NORTH ANNA POWER STATION

*Unit 1 CTS
Mark-Ups*

VOLUME 2

Improved Technical Specifications

Figure 2.1-1 REACTOR CORE SAFETY LIMITS FOR THREE LOOP OPERATION

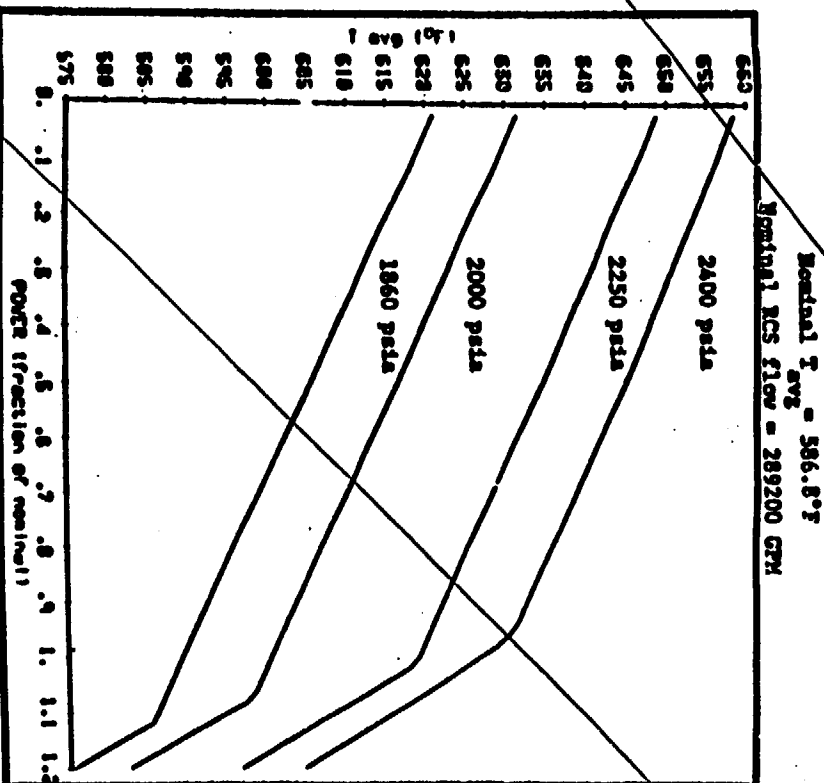
L4.1

Figure 2.1-1a REACTOR CORE SAFETY LIMITS FOR THREE LOOP OPERATION FOR THE PERIOD OF OPERATION UNTIL STEAM GENERATOR REPLACEMENT

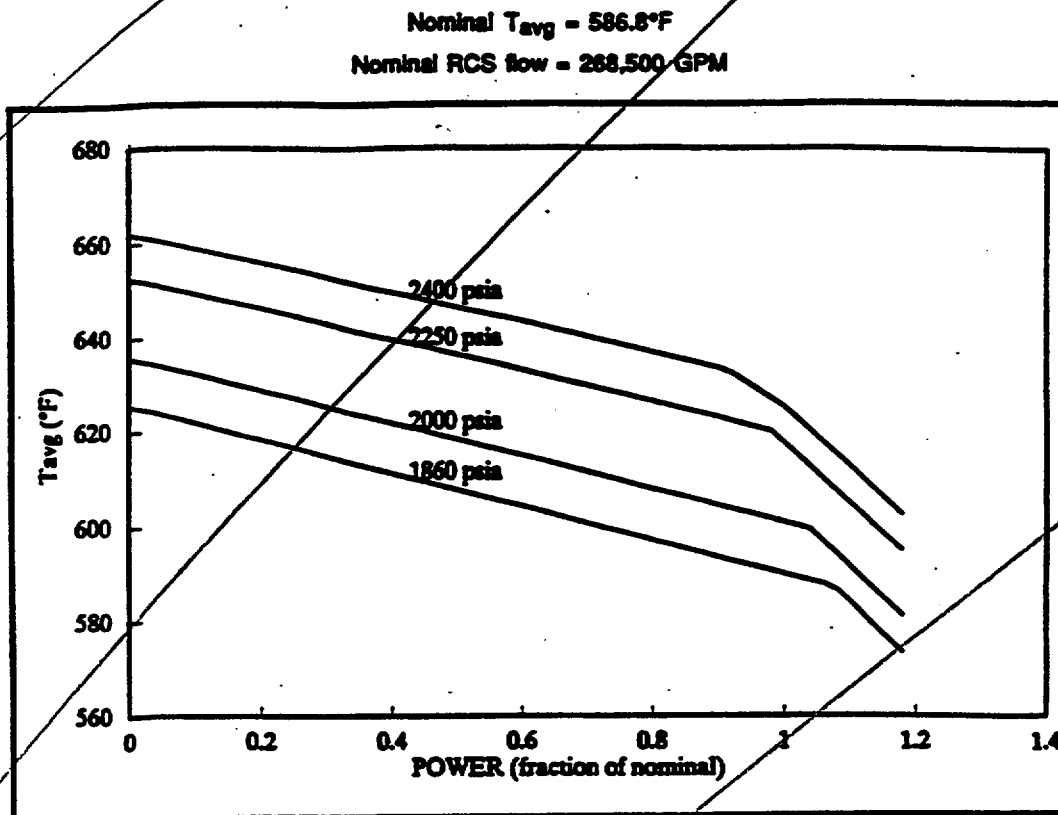
A.3

FIGURE 3.4-1

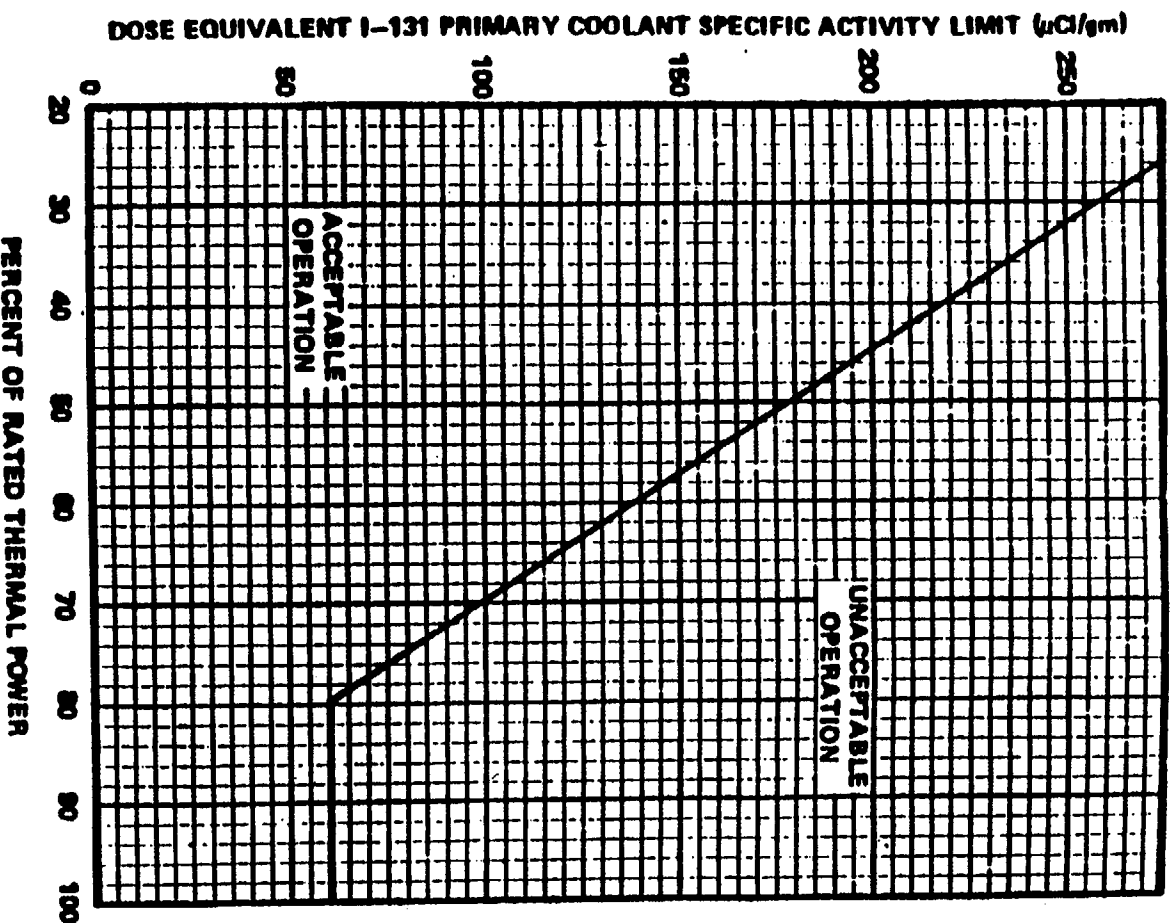
Figure
3.4.16-1
